# Town of Simsbury

*Office of Planning and Community Development*

**Date:** October 6, 2022

**RE:** Application CC # 22-22 of Randee Roucoulet, Owner/Applicant, for the installation of a  $\pm$  64 sq. ft. hot tub in the wetlands on the property at 53 Hickory Hill Road (Assessor's Map C18 Block 606 Lot 002). Zone R-25.

Site Plan of Proposed Work – *Provided by the Applicant*

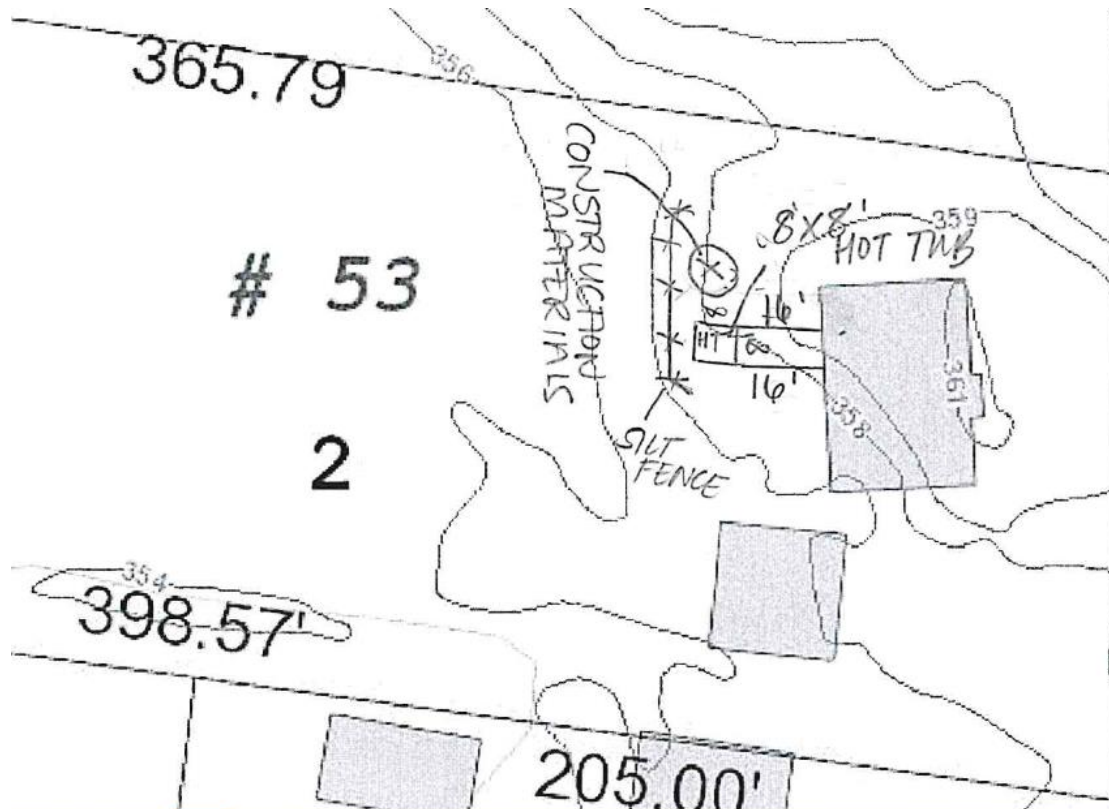
- The soil classification for the proposed activity is Wilbraham and Menlo soils, 0 to 8% slopes, extremely stony, a poorly drained soil type.
- The Applicant has proposed to install a silt fence downgradient of all proposed work. **Staff concur that this is an appropriate erosion and sedimentation control measure for the nature of the proposed work.**

- Staff inspected the stormwater system on September 26, 2022. The red 'X' on the plan generated by staff below shows the approximate location of the outfall that connects to the catch basin to the south of the Applicant's driveway. The green arrow depicts the Applicant's proposal to drain the wastewater from the hot tub into the current stormwater system. The light blue arrow depicts the path the wastewater will travel until entering the headwall located on the Applicant's property. Photos of the stormwater system have been included with the application materials.

1. The project shall be developed in substantial conformance to the site plan provided and signed by the Applicant dated 09/19/2022.
2. The project shall comply with the drainage plan provided by the Applicant on 09/21/2022.
3. Areas of disturbed soils shall be stabilized with the application of loam, seed, required plantings and appropriate erosion control measures.
